AMENDMENT OF SOLICITATION/MODIFICATION OF CONTRACT		BPA NO.	1. CONTRACT ID CODE	PAGE 1	OF 9	PAGES
2. AMENDMENT/MODIFICATION NUMBER 0002		3. EFFECTIVE DATE 2/17/2023	4. REQUISITION/PURCHASE REQ. NUMBER		5. PROJECT NUMBER (if applicable) 884CM3015

14. DESCRIPTION OF AMENDMENT/MODIFICATION (Organized by UCF section headings, including solicitation/contract subject matter where feasible.)						
Project Title: Renovate Administration and Maintenance Buildings Project Location: Black Hills National Cemetery The purpose of this amendments is to: A. Extend the bid due date and time to March 3, 2023, at 10:00AM (CT). B. Provide Bid submission/opening instructions. C. Provide answers to vendor RFI/Questions.						
Except as provided herein, all terms and conditions of the document referenced in Item 9A or 10A, as heretofore changed, remains unchanged and in full force and effect.						
15A. NAME AND TITLE OF SIGNER (Type or print)			16A. NAME AND TITLE OF CONTRACTING OFFICER (Type or print)			
			Shane Hiltz NCA Contracting Officer			
15B. CONTRACTOR/OFFEROR		15C. DATE SIGNED		16B. UNITED STATES OF AMERICA		16C. DATE SIGNED
(Signature of person authorized to sign)				(Signature of Contracti

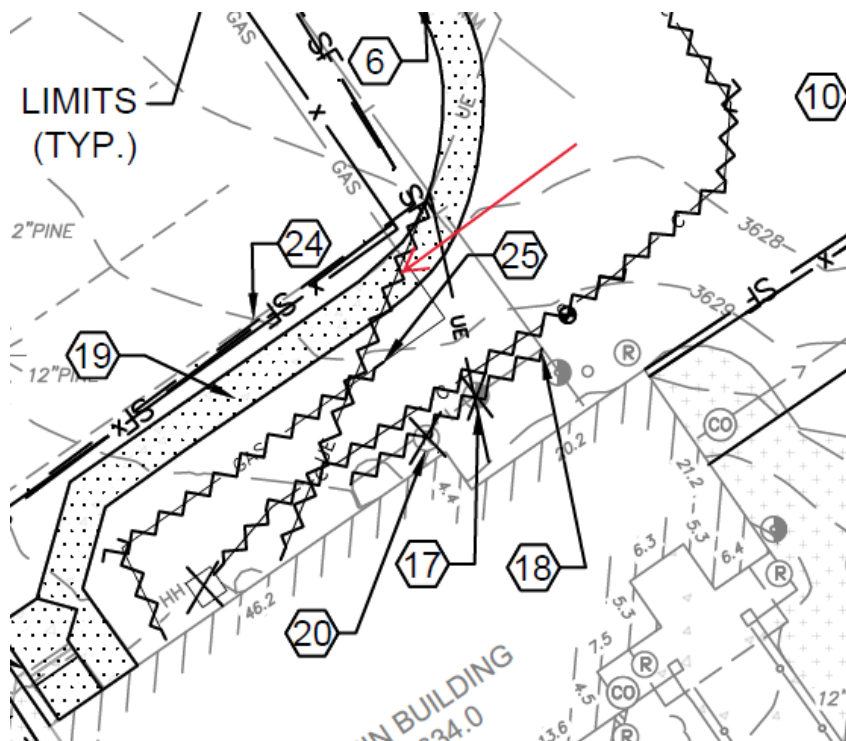
4. On Sheet E101, keyed note 2 states “Intercept existing underground electrical service and extend to new location as shown.” It is unclear where this feed originated and where it currently end up. Please clarify.

D101 and E100 are missing a demolition note showing that the existing underground electrical line is to be demolished. The feed originates underneath the building addition foundation and requires relocation exiting the building to E101 Keynote 3. See sketch below.

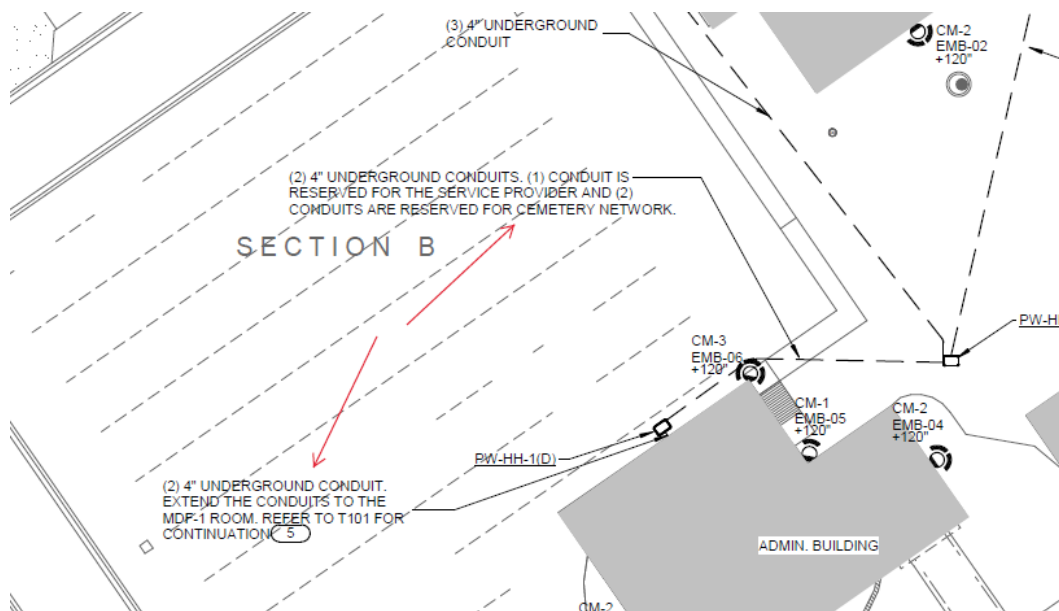
6. On Sheet T100, the note right above section B states (2) 4" conduits. One for the service provider and 2 for cemetery network. Please clarify the number of conduits needed.

This is an error. Only (2) 4" conduits are required at this note.
